MINUTES OF THE MEETING OF THE COMMISSION OF FINE ARTS
HELD IN WASHINGTON, D. C., JULY 28, 1933.

The second meeting of the Commission of Fine Arts, during the fiscal year 1933, was held in its office in the Interior Department Building on Friday, July 28, 1933. The following members were present:

9. STORE BUILDING, CONNECTICUT AVENUE AND CALVERT STREET: Mr. David H. Baer, builder, and Mr. Robert W. Scholz, architect, 1025 K Street, N.W., submitted a design for a new store building, at the northwest corner of Connecticut Avenue and Calvert Street, two stories in height.

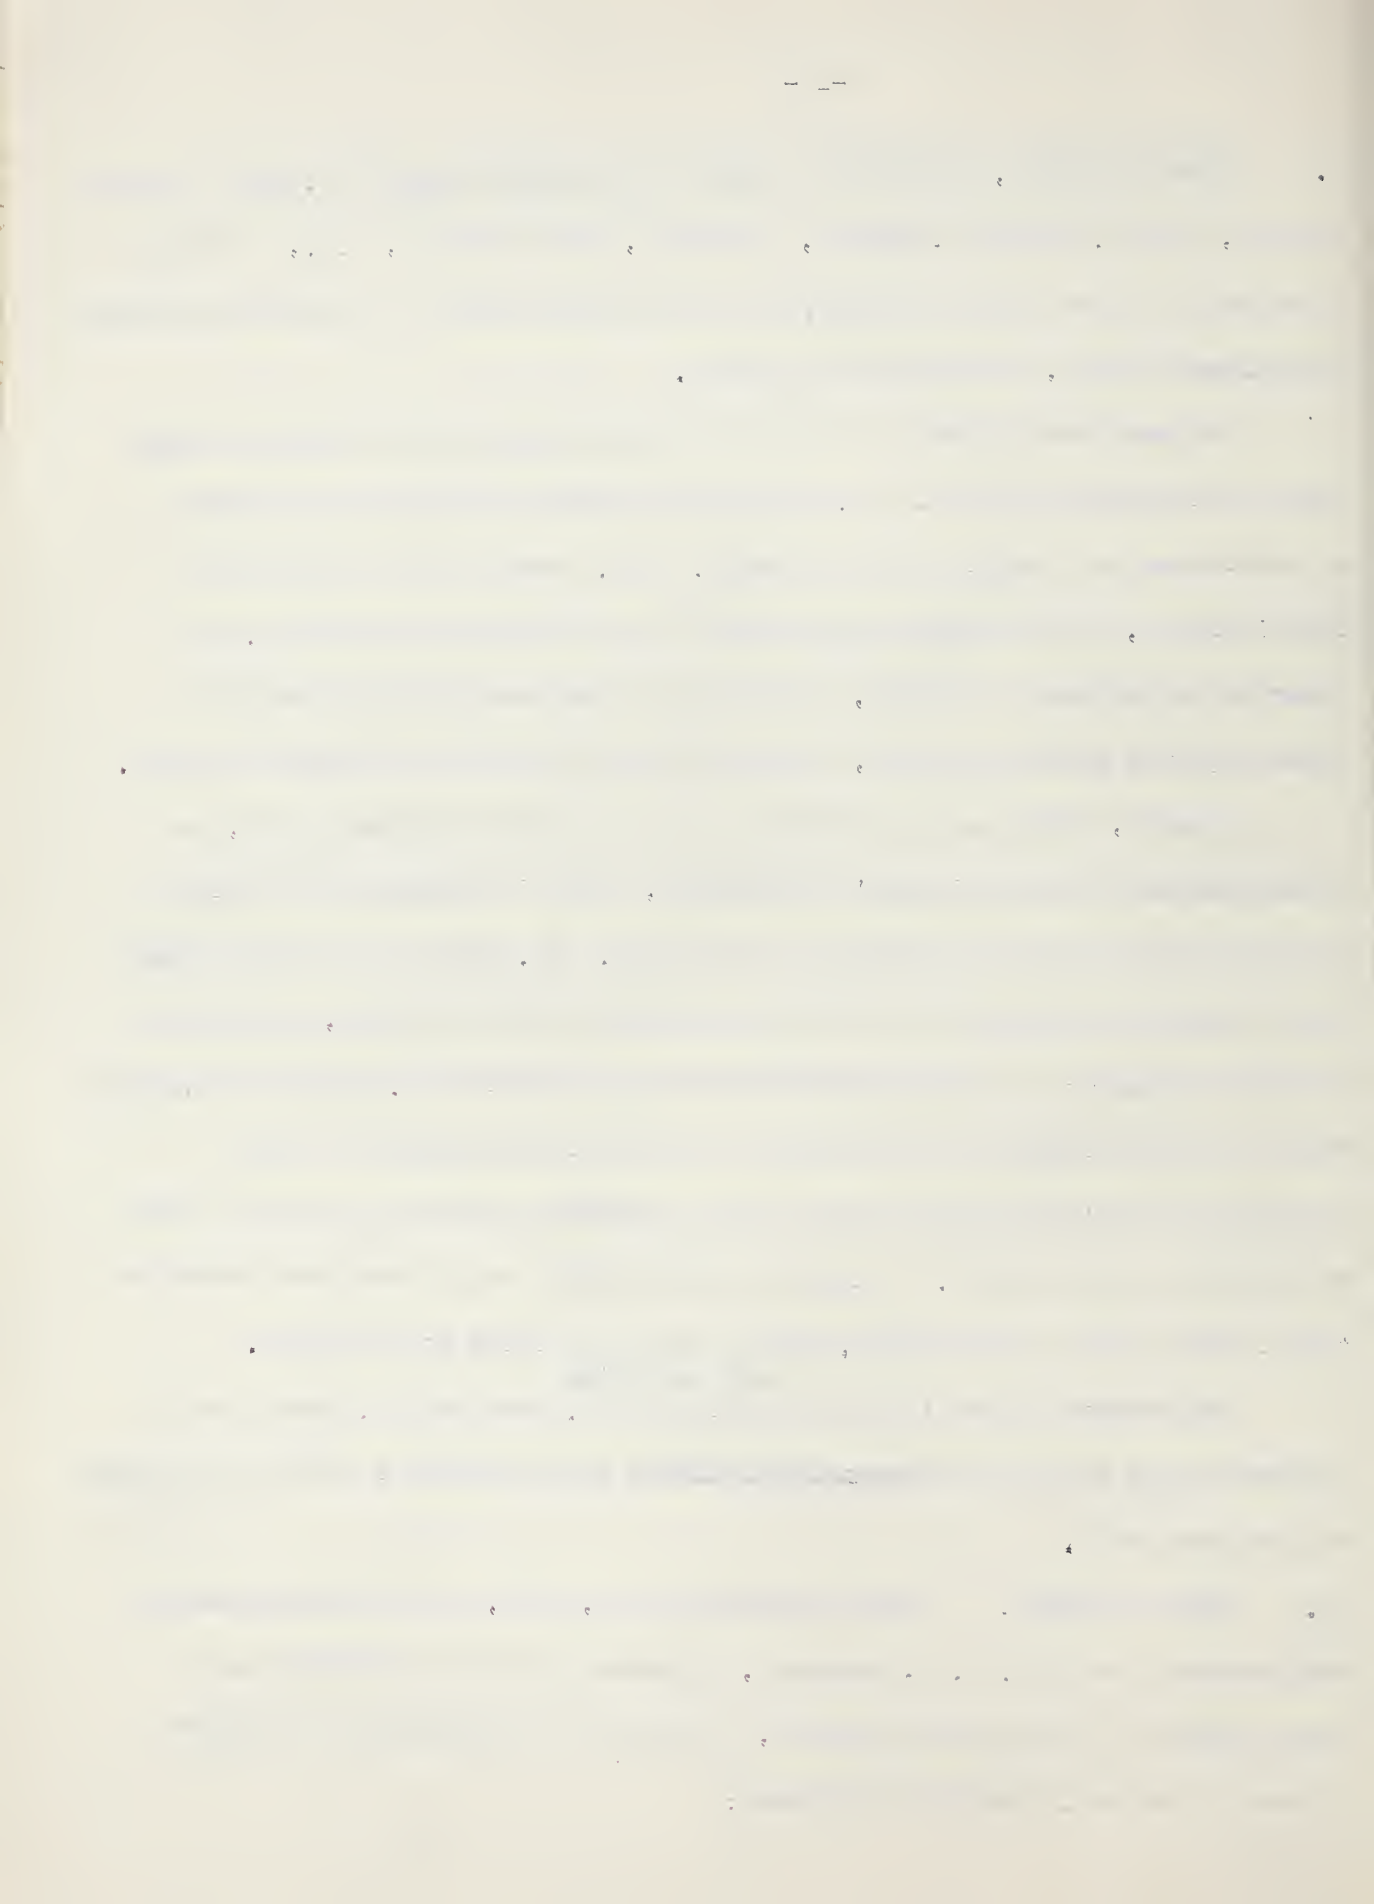
The architect members of the Commission inspected the design and were not at all pleased with it. Mr. Smart out suggested placing the entrance on the corner and simplifying the facade. Mr. Baer said he would like to use limestone, but the Commission thought a light brick was suitable. He regarded the adjacent building, to which the Commission of Fine Arts had given approval a few years ago, much inferior to the one he intends to build.

At noon, during an inspection of the Connecticut Avenue Bridge, the Commission had luncheon in May's Restaurant, which is adjacent to the lot on which the new store building is to be built. Mr. Lauman and other members of the Commission took note of the architecture of the building, and said it was well designed; and requested the secretary to advise Mr. Baer and Mr. Scholz that they were mistaken in saying that the existing building was badly designed and that they should take it for a pattern and build the same style of building to the corner. Also they should take note of the arrangement of the windows on the second floor, and to use light brick for building.

The secretary gave this information to Mr. Baer and Mr. Scholz and a revised design embodying these ~~recommendations~~ recommendations will be submitted to the Commission.
